29 March, 2005

Re: Remarkable unjustified assumptions in economics analyses of the Nam Theun 2 project call for independent review of Nam Theun 2 economics

Figure 1: Comparison between real economic natural gas prices in the *Draft Final* (June 2004) and *Final* (March 2005) versions of the *Regional Economic Least Cost Analysis*. Source: Table 15: Screening analysis of EGAT Candidate Plants (page 30 of Draft Final and page 33 of Final)

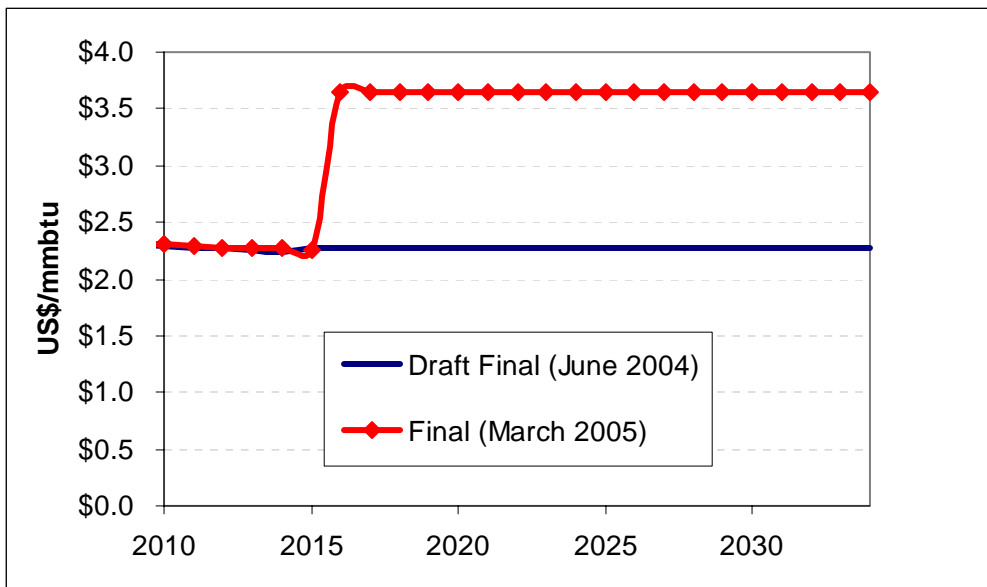
High natural gas cost increase (changed from previous report version without justification). The economic least-cost analysis assesses Nam Theun 2 against electricity from natural gas. The World Bank's *Final Economic Least-Cost Analysis* includes a 61 percent increase in the assumed real economic cost of natural gas starting in year 2016, compared with the Draft Final Report (June 2004)

version of the report⁴. There is no justification for this increase provided in the text. This unexplained increase in natural gas costs comes just 6 years after Nam Theun 2's planned commissioning date, and extends throughout the duration the project evaluation (year 2032), resulting in a considerably more favorable (but unjustified) assessment of Nam Theun 2 compared with electricity from natural gas;

Assumptions about the real economic cost of natural gas fuel in the Draft Final (June 2004) and Final (March 2005) versions of the *Least Cost Analysis* report are shown below in Figure 1. In the Draft Final version of the report, real economic costs in years 2014-2034 are assumed to be nearly constant at \$US 2.27/mmbtu. In the Final version of the report they escalate sharply in year 2016 (six years after Nam Theun 2 commissioning) to \$US 3.65/mmbtu and remain fixed at this high level for the next 18 years (table 15, page 33). There is no justification provided in the text of the Final *Least Cost Analysis* provided for the 61% increase from the Draft to Final versions of the report. Indeed, the only justification for natural gas prices in these years in the text of the Final *Least Cost Analysis* contradicts the actual values used in the analysis and appears to be left over from the earlier draft: “for the end effects period 2014-2034, in the economic analysis the value achieved by 2014 is sustained in real terms” (page 90 of Appendix A3).

Figure 1: RELC assumptions for annual CCGT O&M costs compared with Thai and international benchmark values. (Graph of data in Table 2). Notice that RELC/2004 costs were similar to Thai and international benchmark figures, but RELC costs are more than twice as high as the highest benchmark.

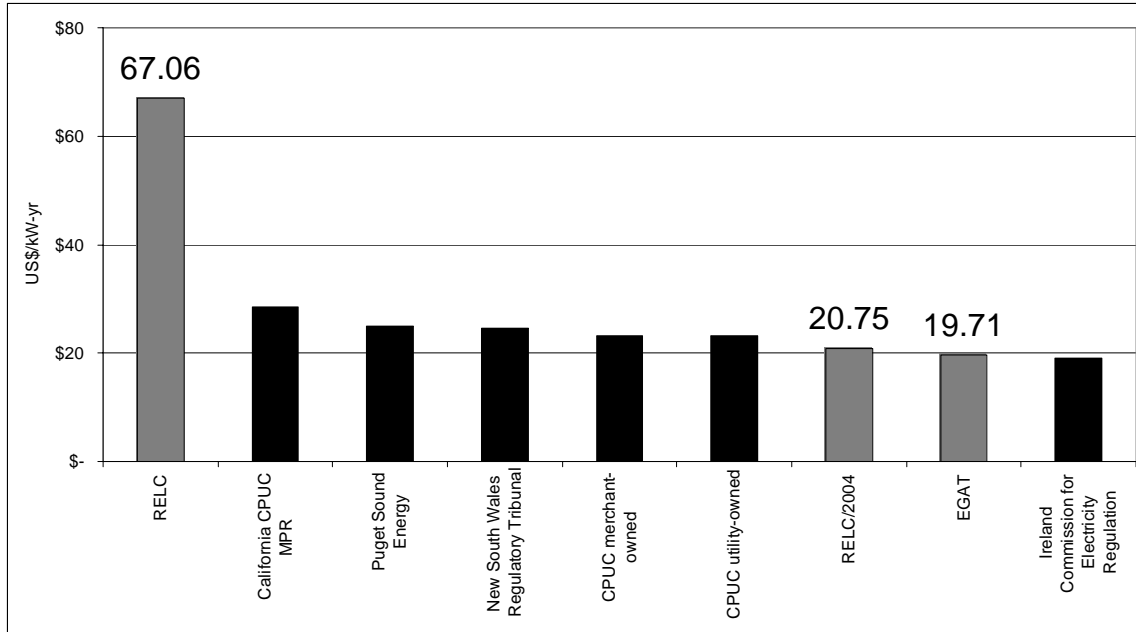
Perhaps the most startling feature in Table 2 (graphed in Figure 1) is that the RELC O&M values are by far the highest values in the table. Though we conducted an extensive internet search of CCGT O&M costs, *we were unable to find O&M costs anywhere in the world that were even half as high as those assumed in the RELC*. To the best of our knowledge, these cost estimates all include insurance, inspection and maintenance. In addition, the international benchmark values are generally *commercial* O&M costs, and therefore overstate *economic* costs because they do not include profits or taxes. They cover the spectrum from utility-owned generation to independent power producers. In our international search, the highest assumptions we encountered (besides the RELC figures) were those used in avoided cost calculations by the California Public Utilities Commission (CPUC). Consider that California has extremely high labor costs and some of the strictest environmental regulations for power plant emissions in the world. We are surprised that the Bank believes that O&M costs for CCGT in Thailand, which has fairly low labor costs, would be more than twice as high as CPUC cost estimates.

Perhaps more important than the international benchmark values are the Thai EGAT values. The RELC cost estimates for total O&M are 340% as large as EGAT total O&M cost estimates. EGAT has an extensive record running CCGT in Thailand. For new EGAT plants, it seems appropriate to use EGAT O&M costs.⁸ At the same time, one would not expect EGAT costs for CCGT O&M in Thailand to be *that* different from private sector costs. EGAT typically has a larger workforce per plant than private sector Independent Power Producers (IPPs), but IPPs may pay somewhat higher salaries -- these two effects would tend to compensate for each other. Our research finds evidence that insurance costs for utility and IPP CCGT are similar and account for a fraction of total O&M costs.⁹

1. A detailed justification for the exceptionally high economic cost estimates for O&M of CCGT. Given the importance of this variable, and the radical escalation of its value in the *RELC* it deserves more than the 6-point font footnote to Table 13. Specifically, the justification should include a discussion of the conditions in Thailand that lead to O&M CCGT costs that are far above international levels and published EGAT figures.
2. An explanation of why published EGAT figures are not relevant for the *RELC* analysis.
3. An explanation for why there was no discussion in the text of the *RELC* of the 1240% escalation in CCGT and 1000% escalation in GT VOM values. We find this omission astounding considering that this change accounts for more than half of the “with NT2” savings and that the values assumed are exceptionally high by international standards.

We have reviewed the analysis of operations and maintenance (O&M) costs you have carried out. These data are drawn largely from the US and show a fairly narrow range of O&M costs – between 0.27 US cents/kWh and 0.41 cents/kWh. This range is far narrower than the range of O&M costs identified in the Bank’s own investigations. Our analysis, drawn largely from international data, project feasibility studies, and internal Bank studies and reports, demonstrates that O&M costs vary markedly between projects, as summarized in the table in Attachment 1. This table shows a range of total O&M costs from 0.32 US cents/kWh to 0.69 cents/kWh, based on plants in diverse locations in Europe, Asia, the Middle East, Africa and North America. (The table expresses all data, including the data you have provided, in the common numeraire of US cents/kWh, assuming an illustrative 80 percent plant factor for the fixed O&M component.)

You will note that the figure adopted for the RELC analysis – 0.76 US cents/kWh¹ – is slightly above this range and considerably above the value used in RELC/2004. The Bank selected this higher value based on engineering advice that we had seriously underestimated this cost in the earlier report, and that technical and environmental performance characteristics of *future* privately-financed plants will result in much higher O&M than in the past.²
